Front Axle Driveshaft - Oil Leak		30/10/96 NRR/54/03/96/EN
MODEL New Range Rover	AFFECTED VEHICLES LP 348603 Onwards LH LJ LD

ILLUSTRATION

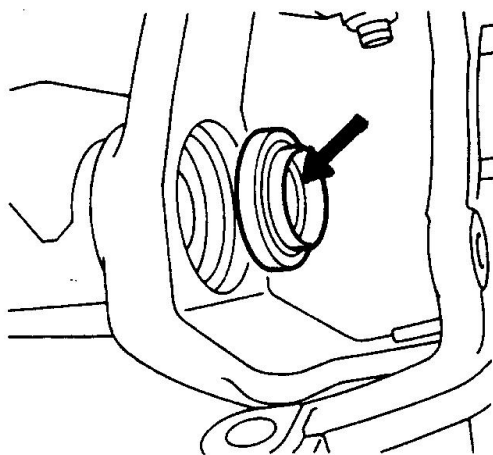
In the event of an oil leak becoming evident from the front driveshaft seal around the yolk area, a new driveshaft seal has been introduced.

Upon customer complaint of an oil leak around the driveshaft area, the new revised seal should be fitted, together with the brake caliper bolts and hub assembly bolts as detailed in the parts section.

FTC 4822 replaces FTC 3452 driveshaft seal

FTC 2996 brake caliper bolts (4 off)
FC 112127P hub assembly bolts (8 off)

Note: New service tool No LRT-54-012 should be used in conjunction with the driveshaft seal.
